100 Avenue Road, NW3 3HF Amended CMP

Delegated Report		Analysis sheet	Expiry Date:	NA
(Members Briefing)		N/A	Consultation Expiry Date:	NA
Officer			Application Numbers	
Planning Obligations			Approved CMP ref. 2017/6638/CMP Original application ref. 2014/1617/P	
Application Address			Documents Considered	
100 Avenue Road London NW3 3HF			Construction Management Plan dated 01/11/2019 Draft Responses to the proposed Amended CMP dated 12/11/2019	
PO 3/4	Area Team Signature	C&UD	Authorised Officer Signature	
Proposal				
Amendments to vary the Approved Construction Management Plan (CMP) under 2017/6638/CMP, for a mixed used development (24 storey and 7 storey buildings with residential units, flexible retail/café/restaurant space and community use) approved under 2014/1617/P dated 18/02/2016				
Recommendation:		Approve the Amended Construction Management Plan		
Application Type:		NA

Figure 1 (above): Proposed site plan showing vehicle routes within the Amended CMP.

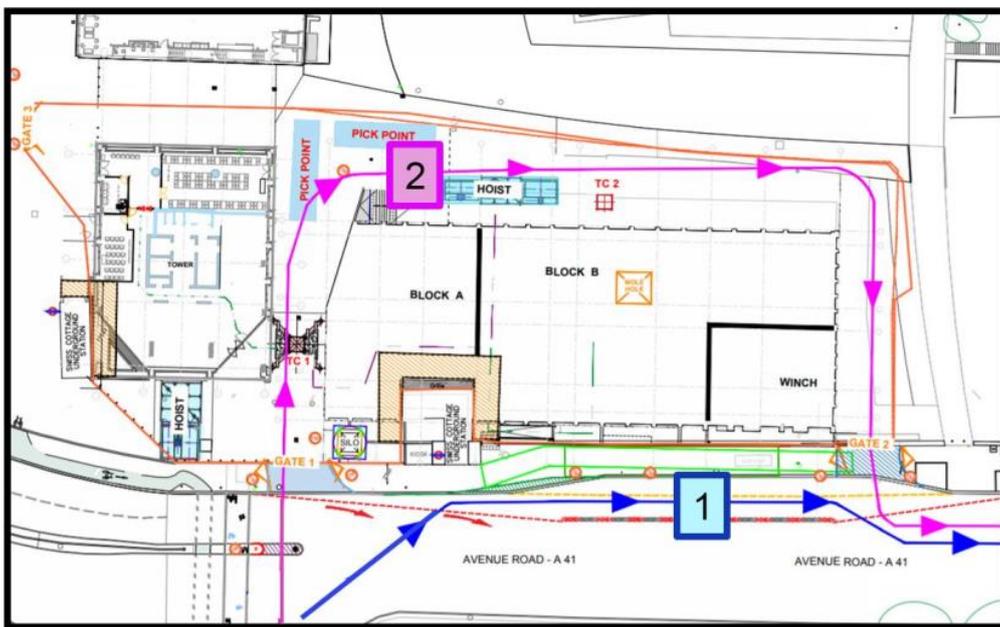
3.4 A visual showing the new lorry route/entrance is available on the following link - <https://www.youtube.com/watch?v=jIRJBw4Qhio&feature=youtu.be> – vehicles would travel around the gyratory before entering the site from the intersection (using the light phasing). It is noted that this is a visual representation of the route lorries would take, rather than an accurate portrayal of likely traffic conditions. The new route is shown on the plan below (Figure 1, new route labelled as 2). Route 1 is the pit lane and route 2 is the proposed route entering through a new entrance to the north of the Underground Station entrance and out through the existing access point adjacent to the Swiss Cottage open space. The hoarding line and area of open space required would be similar to that within the Approved CMP.

3.5 The proposed vehicles within the Amended CMP include a maximum vehicle length of 16.5m (Category C+E), which is an articulated lorry, shown in Figure 2 below. This is approximately 54 feet and 2 inches long.
